C-AD

Safety Minutes of Radiation Safety Committee of August 10, 2006

Subject: ERL Critical Devices, Klystron Room, and Fault Protection

Various views of the beam dump and shield. The shield has counter weights for rigging.

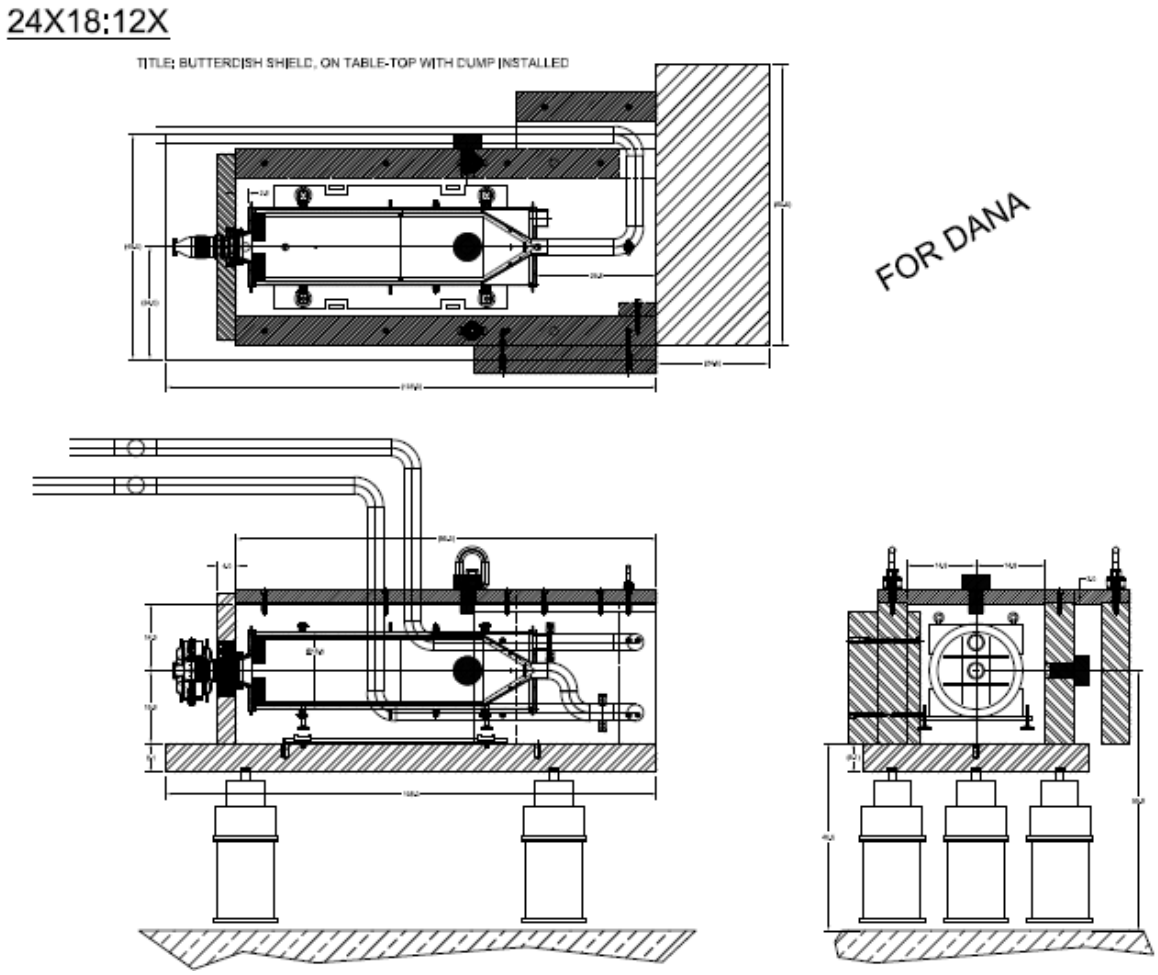
to be about 6 inches thick on the sides and 3 inches on top. A distance of 10 meters was used for the estimation of the concentration, which may be too large a value. The concentration will depend of air circulation, incidental venting, etc. The air quality will be sampled for the first few operations to provide an empirical measure of the ozone production and concentration. **(Ck-FY2012-ERL-804)**

Various views of the beam dump and shield. The shield has counter weights for rigging.

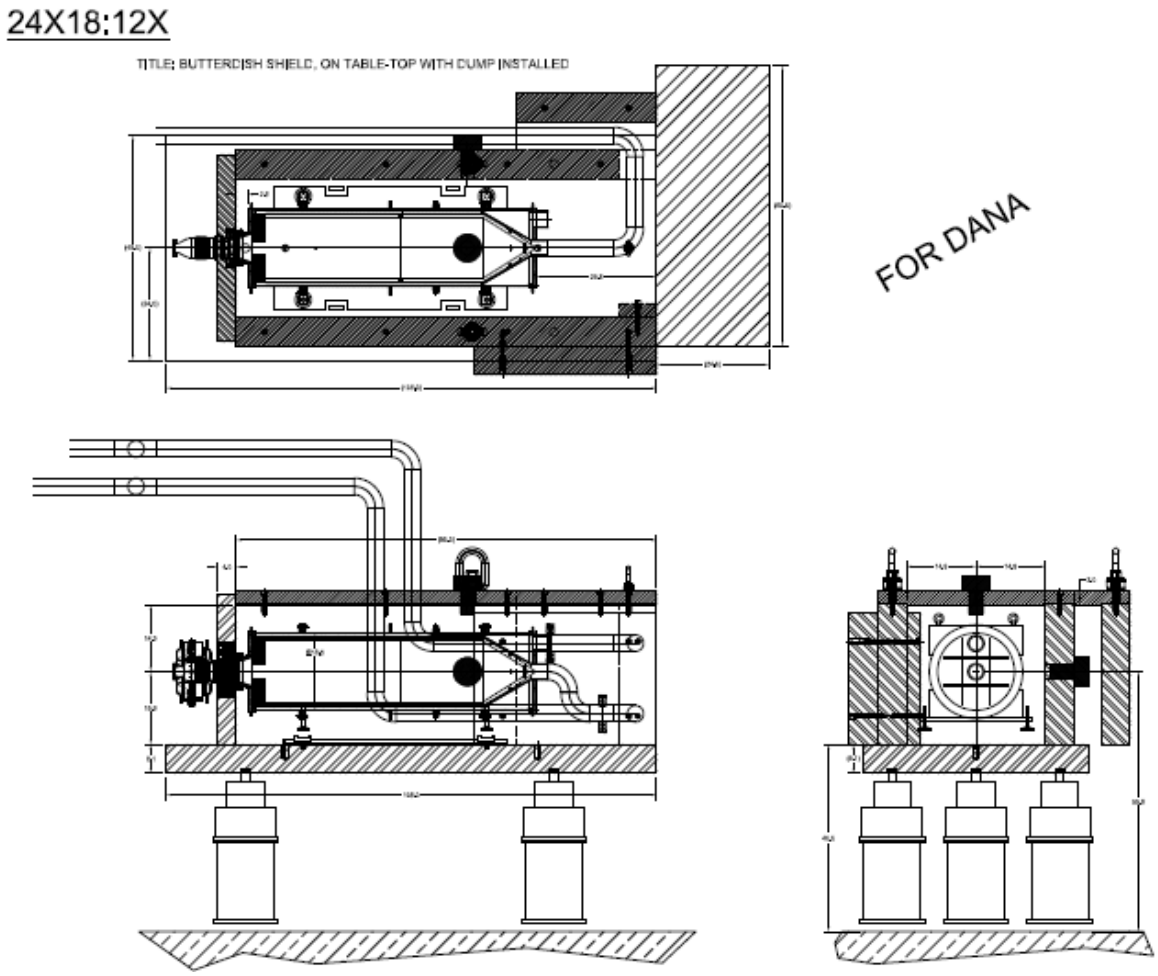
The production of ozone in the air surrounding the beam dump was estimated[2] to be 1.6 PPM per hour with no shielding. At that time the beam dump shield was estimated to be 0.25 meter thick and the ozone production would have been reduced by about 10^{-4}. The shield has been designed to be about 6 inches thick on the sides and 3 inches on top. A distance of 10 meters was used for the estimation of the concentration, which may be too large a value. The concentration will depend of air circulation, incidental venting, etc. The air quality will be sampled for the first few operations to provide an empirical measure of the ozone production and concentration. **(Ck-FY2012-ERL-804)**

Figure 1: Model used to simulate ERL roof transition.

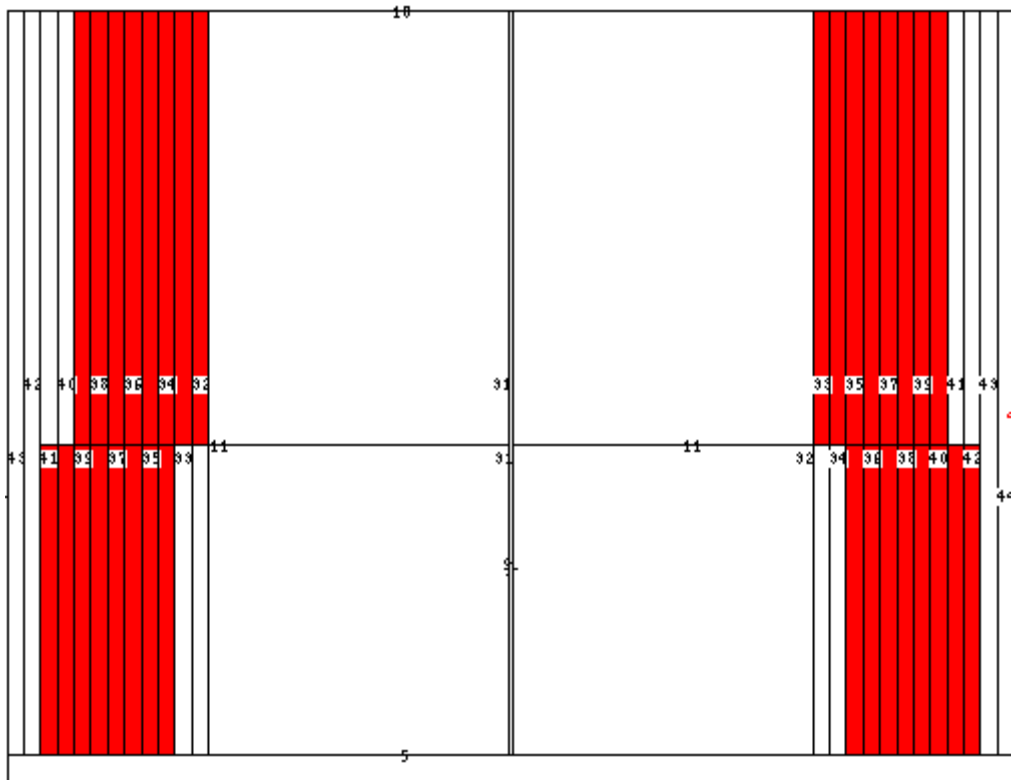
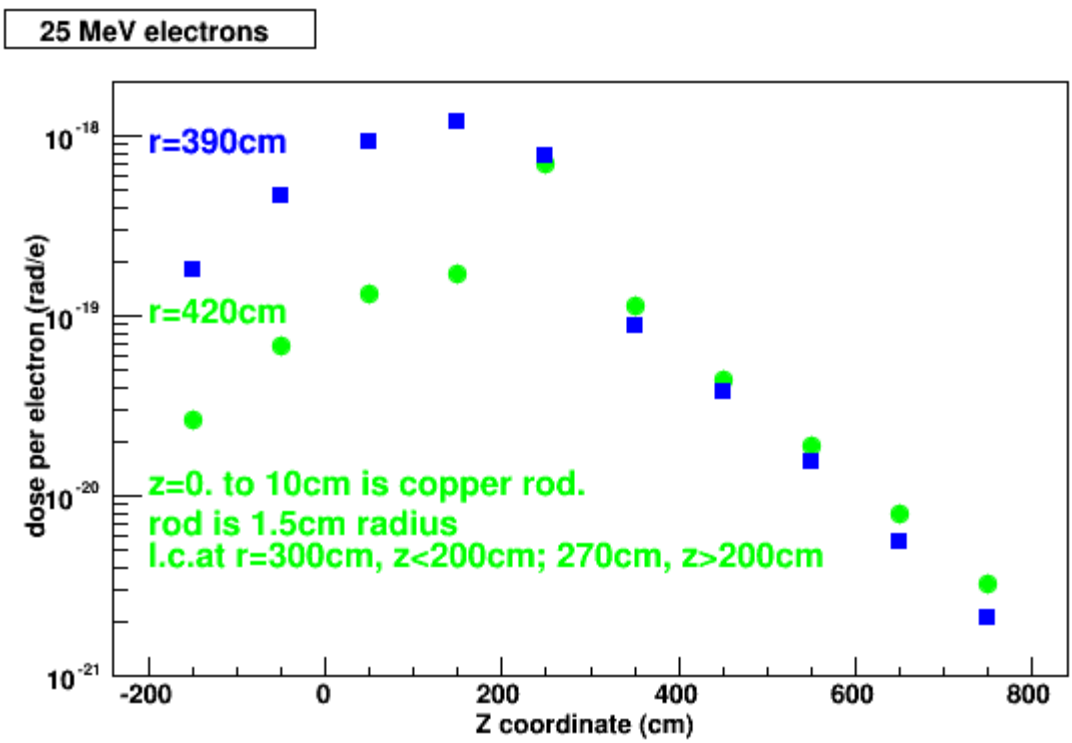
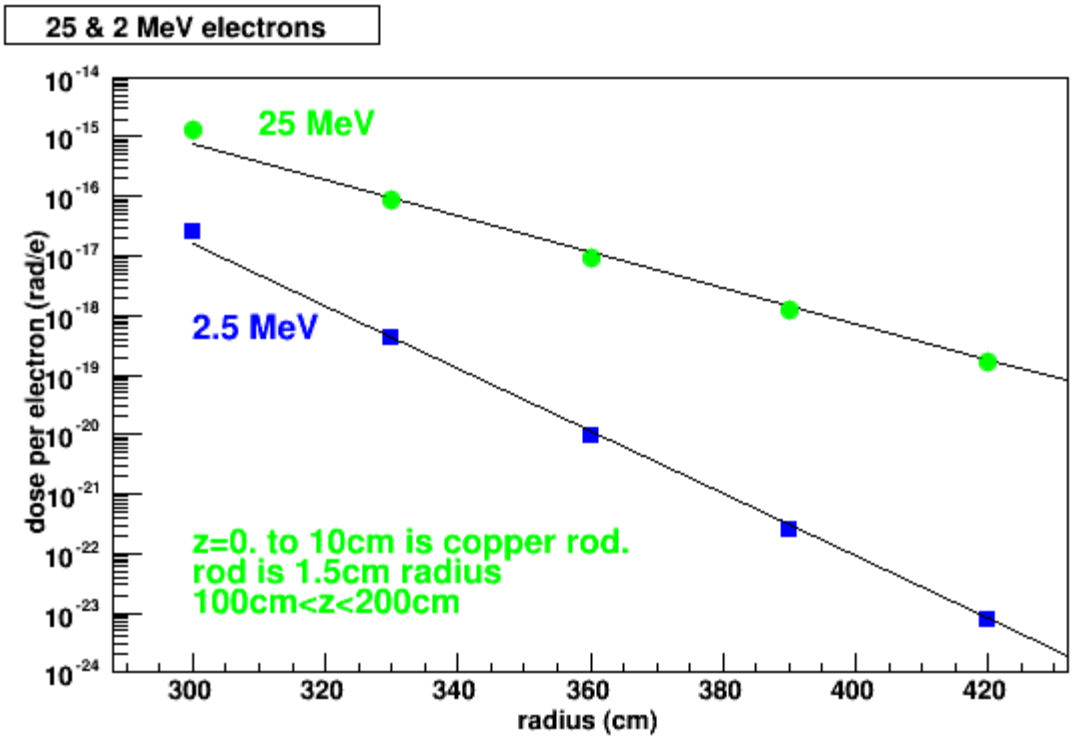
The initial design of the ERL roof was at a fixed height of 13 feet above the floor. To aid in rigging operations the central section of the roof was raised to 14 feet forming a transition at both end of the area. To examine the impact of this change on radiation dose through the roof a simple model was used in MCNPX[1].

The roof transition appears to produce a localized elevated dose rate consistent with three feet of effective shielding. The dose rates for the 10W test are not an issue for the transition. The radiation hazards from other weaknesses such as the cracks or the roof ODH vent are probably more relevant concerns if someone accesses the roof. For higher power tests in the future it will be important to correlate the dose rates at the chipmunks to the dose rate on the roof including the weak locations.

Figure: Plan view of shield and dump area, drawing 010606213.

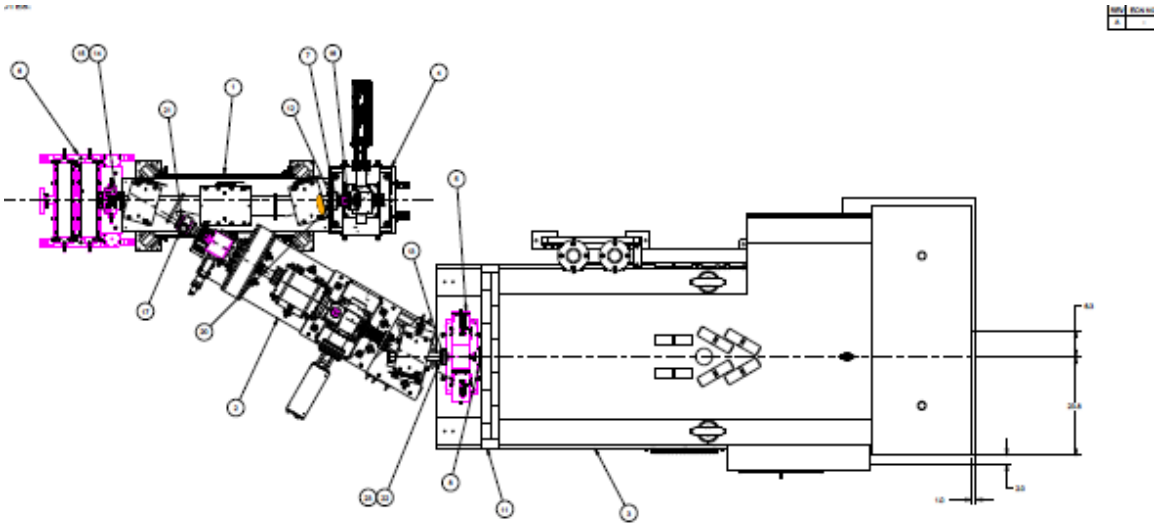
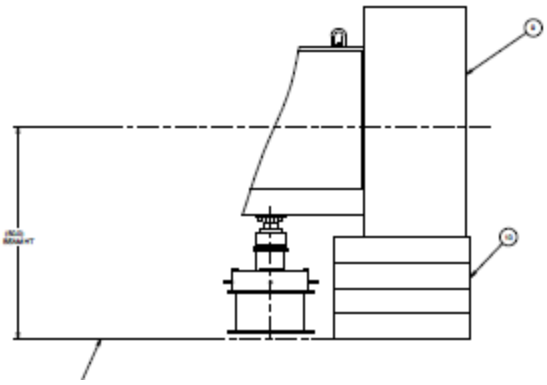
The project would like to change the design of the end steel. A cast-iron B block will be centered about the beam dump in both vertical and horizontal directions. This will eliminate in the shield materials near beam height. The final design needs to consider whether the cast-iron B block needs shielding on top. It was noted that the block serves to shadow the labyrinth wall from both losses in the beam lines and from the radiation generated in the beam dump.

1. Update appropriate prints to QA-1 including the Pb shielding
2. Band and post the Pb shield.
3. Archive the results of the Pb analysis
4. Modify plug and attach both
5. Finalize end shielding design
6. Determine configuration past first dump dipole and analyze.

Figure IV: Pb shielding covering the entrance of the laser port inside the ERL shielding. The Al spacer does not shield the bored hole. The one inch diameter laser pipe is not shown.

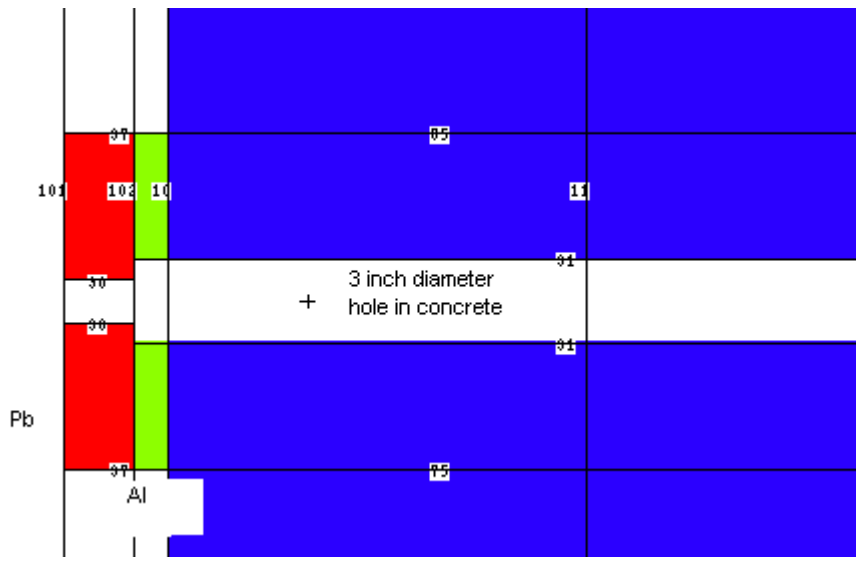
The laser port was originally a rectangular port with dimensions 3 by 4 inches. The port was shadowed by the shielding[10] for the one megawatt waveguide. It became desirable to have the laser port in another location so a 3 inch diameter hole was bored through the shielding at a location approximately transverse to the first beam halo scrapers. The dose rate out the original laser port was estimated assuming that the port was shadowed by approximately two feet of heavy concrete. The new laser port is not shadowed for beam losses in the upstream transport. The dose rates out the laser port have been estimated using MCNPX in two stages. The first calculation provided the energy distribution and dose for electrons and photons. These distributions were binned in energy and then used as a source input in MCNPX. The source directed photons and electrons onto the area of the port based for the existing geometry. The simple model[11] of the shield wall with the Al spacer and the 1 inch lead shield is shown in Figure IV.

The calculation used the 0.1 cm diameter rod on the beam line 255 cm away from east side wall and 137 cm above the port. For 100 Watts of 3.5 MeV electrons the dose immediately outside the port is 14 mrads/hr. At a distance of one foot from the wall the dose rate is 10 mrads/hr. Beam faults with beam power of 1000 Watts are not expected to be sustainable although this assertion has not been proven. If necessary additional shielding can be placed inside the ERL enclosure if the laser pipe valve is moved. The old laser port has some critical length cables being routed to equipment and cannot be completely plugged. The Faraday cup for the first beam test has two feet of heavy concrete between it and the new laser port. The first halo scrapper has no shielding between it and the new laser port and will be used for a fault study if possible. The halo scrappers will be locked in the open position until the machine is ready to conduct fault studies on the scrapper.

Figure V: Cross-sectional view of the round cryogenics pipe in the square hole for the west shielding. The pipe extends well into the enclosure but in the model is terminated two feet from the exterior of the shield wall.

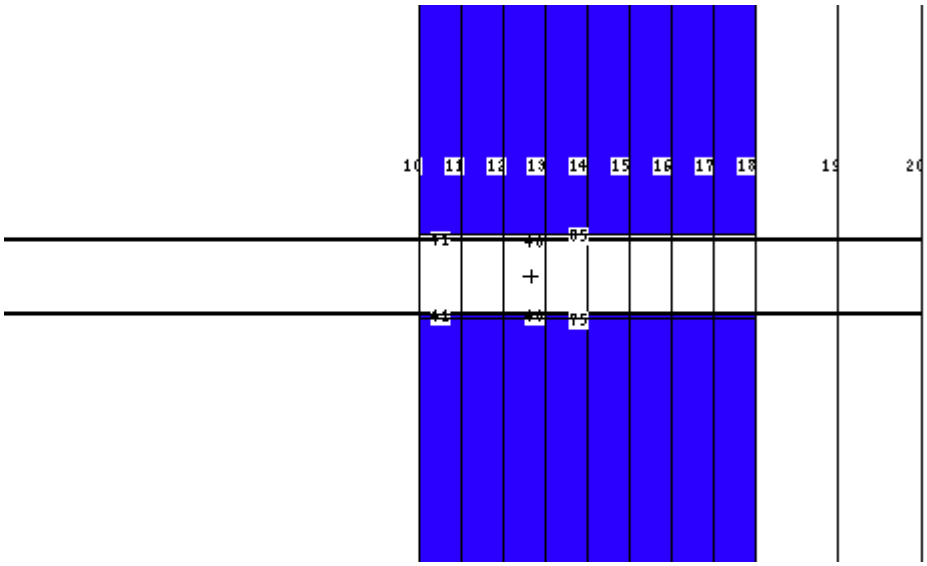
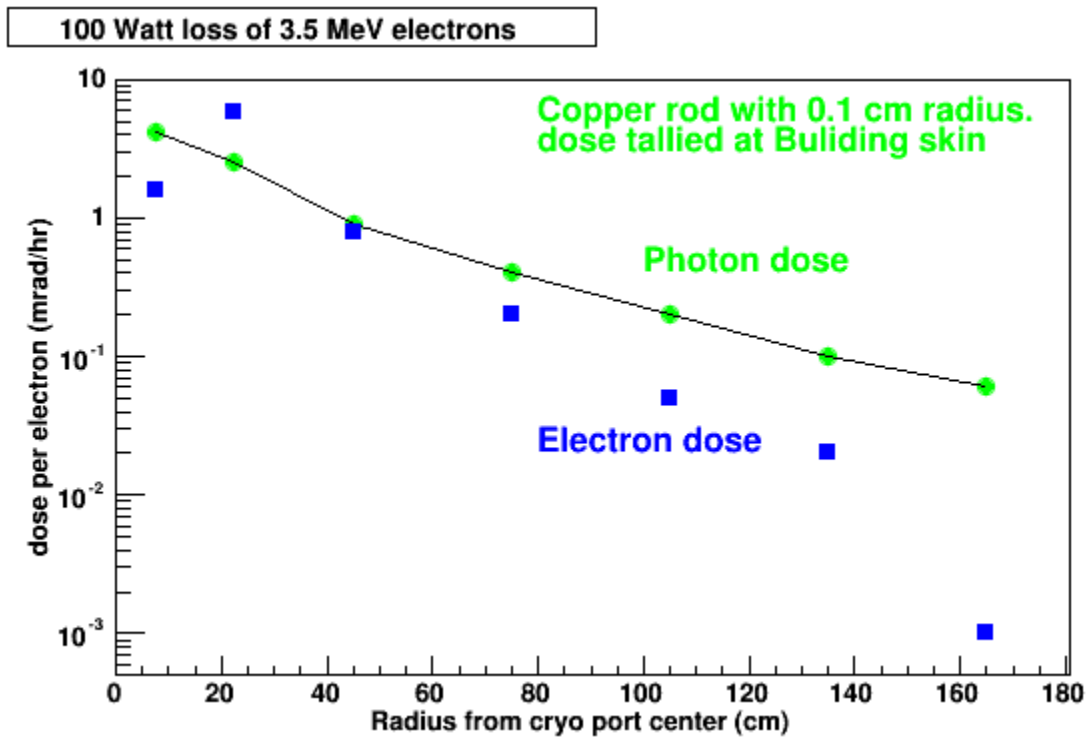
The cryogenics piping penetrates the shielding at an elevation of 13 feet. Square ports with sides 12 inches where placed in the shielding for the piping. There are four such ports on the west wall. The area beneath the ports will be swept and access controlled. Access requirements may change after radiation surveys are conducted for the shielding seams[12] and cryo-piping. An example of the geometry[13] used in the MCNPX analysis is shown in Figure V. The correct pipe wall thickness is used but it is assumed that the pipes are empty.

The photon dose rates as a function of radius from the pipe axis is shown in Figure VI. The dose rates are given at 930 cm from the beam line, which is the position of the building wall. The two stage technique discussed for the laser port was also used for the cryo pipes. The structure in the electron dose is caused by the cryo pipe absorbing the scattered electrons but some outer areas of the port the electrons are not shielded by the pipe. The dose rate fo a 100 Watt loss in the lower energy beam line is less than 10 mrads/hr. An interlocking chipmunk is located approximately 60 cm from the vent pipe and 90 cm from the vacuum jacketed cryo pipe. The interlock threshold is 2.5 mrads/hr which would like the peak dose out either of these ports to less than 25 mrads/hr. This chipmunk is not effective[15] in limiting the dose out the upstream cryo-pipe ports for beam losses some early sections of the low energy transport.
